# UNITED STATES PATENT AND TRADEMARK OFFICE

APPLICATION NO.	FILING DATE	FIRST NAMED INVENTOR	ATTORNEY DOCKET NO.	CONFIRMATION NO.
09/752,344	12/29/2000	Jan Suumaki	460-009995-US(PAR)	8635

**Office Action Summary**

### **DETAILED ACTION**

**Fig. 1**

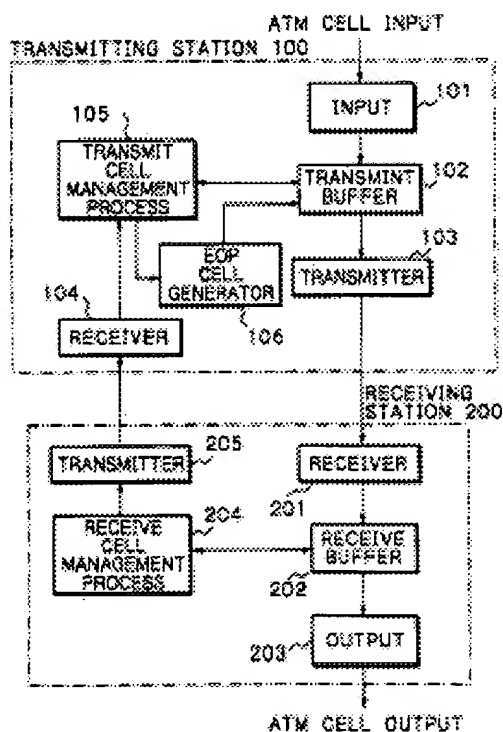
**As per Claims 1, 11-12, Umeuchi et al.** depicts, e.g., in Fig. 1 and related description in col. 3 line 40 et seq., the claimed method for making data transmission in a telecommunication network more effective, which comprises layer structure protocol means for data transmission, which protocol means comprise at least an upper layer and a lower layer, wherein the purpose of the lower layer (col. 3 line 45) is at least to compose a data unit (col. 3 line 44) to be transmitted to the upper layer (col. 3 line 45) from one or more segments (col. 3 line 43, col. 12 lines 45-48 & Fig. 8), in which method one or more errors (col. 3 line 50) occurring in the received segments (col. 3 line 50) is detected wherein said data unit to be transmitted to the upper layer

(e.g., col. 6 line 15 et seq.) is composed from one or more segments which contain one or more errors (col. 3 line 50), wherein information on the location of one or more errors (col. 3 line 50, col. 3 line 43, col. 12 lines 45-48 & Fig. 8) is also transmitted to the upper layer.

As per Claim 2, Umeuchi et al. depicts, e.g., in Fig. 1 and related description in col. 3 line 40 et seq., the claimed method in which it is also detected that an entire data unit (col. 3 line 50, col. 3 line 43, col. 12 lines 45-48 & Fig. 8) to be received is missing (col. 3 line 50, col. 3 line 43, col. 12 lines 45-48 & Fig. 8) characterized in that the location of the segment (col. 3 line 50, col. 3 line 43, col. 12 lines 45-48 & Fig. 8) of said missing data unit (col. 3 line 52: lost or missing) in the data unit (6) to be composed is interpreted as an erroneous area (col. 3 line 50, col. 3 line 43, col. 12 lines 45-48 & Fig. 8).

As per Claim 3, Umeuchi et al. depicts, in Fig. 1 and related description in col. 3 line 40 et seq., the claimed method in which the erroneous data units (1 a, 1 b) are corrected in the lower layer within a determined delay using acknowledgements and retransmissions, characterized in that in the lower layer the data unit to be transmitted to the upper layer is composed from segments located in the received data units after all data units are received accurately, or when within a given delay there is not enough time to correct the erroneous or missing data units by means of retransmission, e.g., in Fig. 2: S13, 21 and col. 6 line 45 et seq., for delay, acknowledgements and retransmissions means.
